Northeast Nuclear Energy Company

(Millstone Nuclear Power Station,
Unit No. 3)

SUMMARY OF FACTS, DATA, AND ARGUMENTS ON WHICH NORTHEAST NUCLEAR
ENERGY COMPANY PROPOSES TO RELY AT THE SUBPART K ORAL ARGUMENT

Reference 1

**FIGURE 3.9-1 Minimum Fuel Assembly Burnup Versus Nominal Initial Enrichment
for Region 1 4-OUT-OF-4 Fuel Storage Configuration**

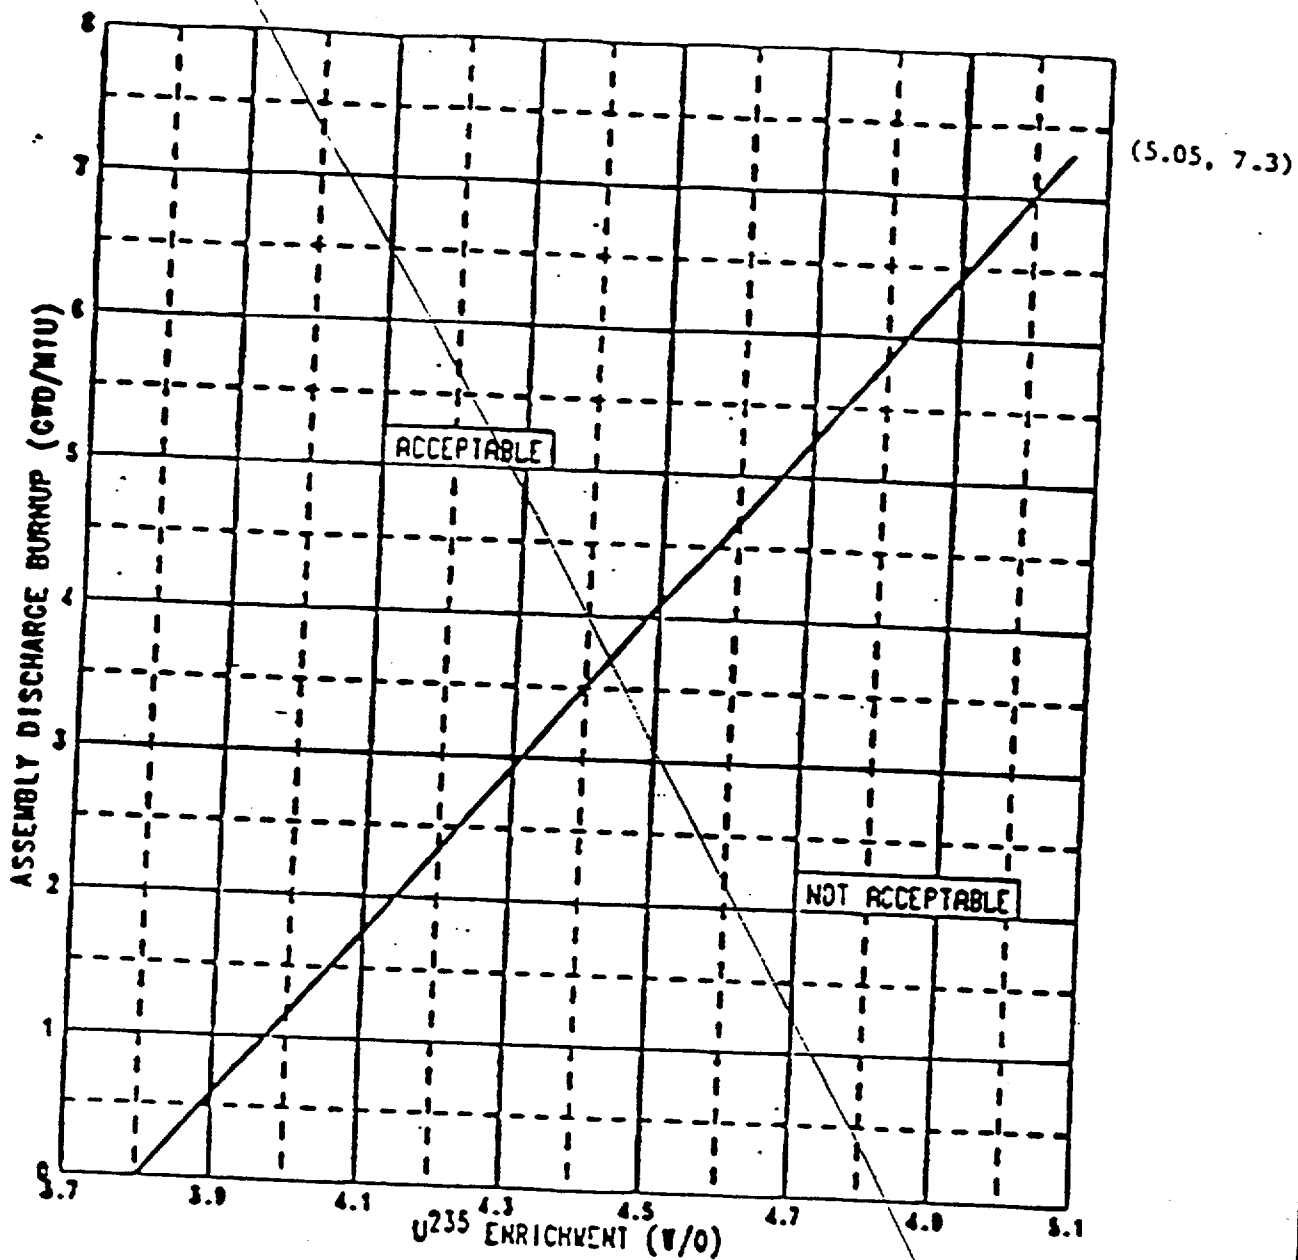
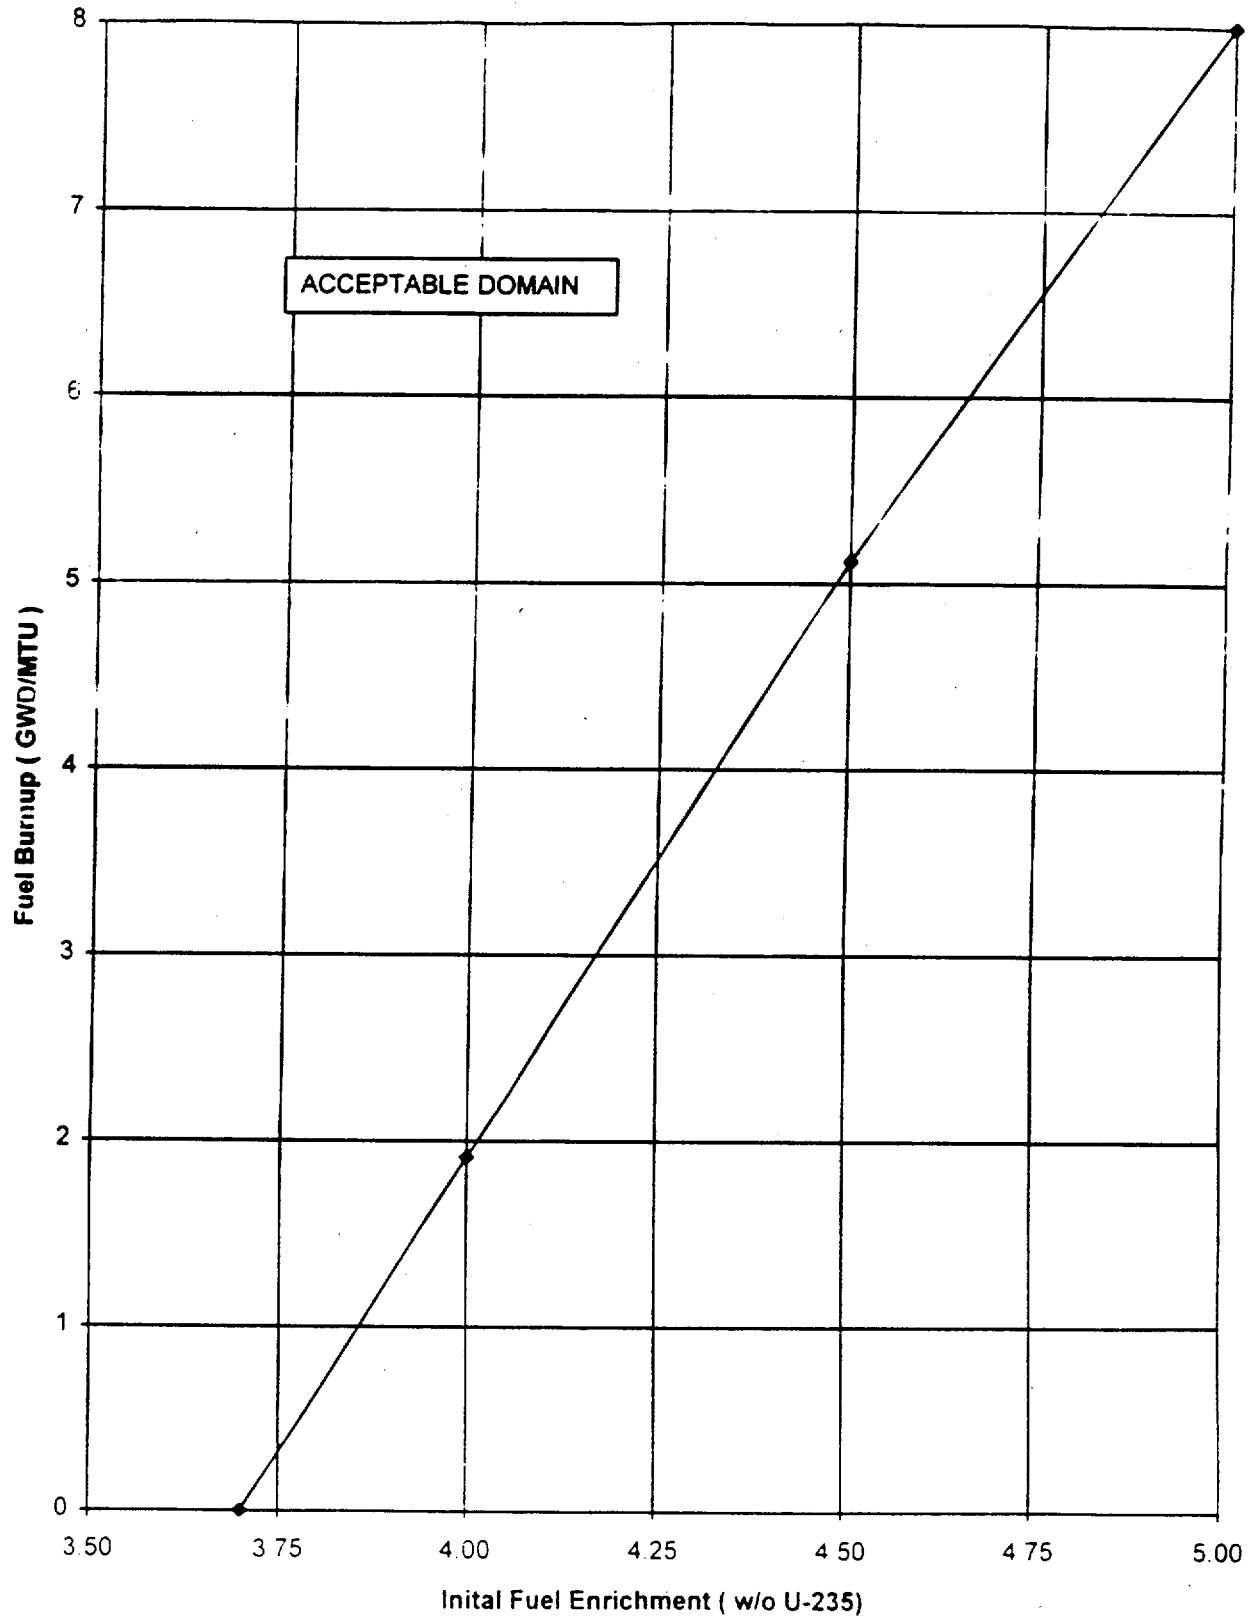
Replace Figures 3.9-1 and 3.9-2 with new figures 3.9-1, 3.9-2, 3.9-3 and 3.9-4 indicating storage requirements for the proposed Regions 1, 2 and 3 fuel racks.

Replace

- 4.9.13.1a.1 Ensure that all fuel assemblies to be placed in Region 1 "4-OUT-OF-4" fuel storage are within the enrichment and burnup limits of Figure 3.9-1 by checking the fuel assembly's design and burn-up documentation.
- 4.9.13.1a.2 Ensure that all fuel assemblies to be placed in Region 2 fuel storage are within the enrichment and burnup limits of Figure 3.9-3 by checking the fuel assembly's design and burn-up documentation.
- 4.9.13.1a.3 Ensure that all fuel assemblies to be placed in Region 3 fuel storage are within the enrichment, decay time, and burnup limits of Figure 3.9-4 by checking the fuel assembly's design, decay time, and burn-up documentation.
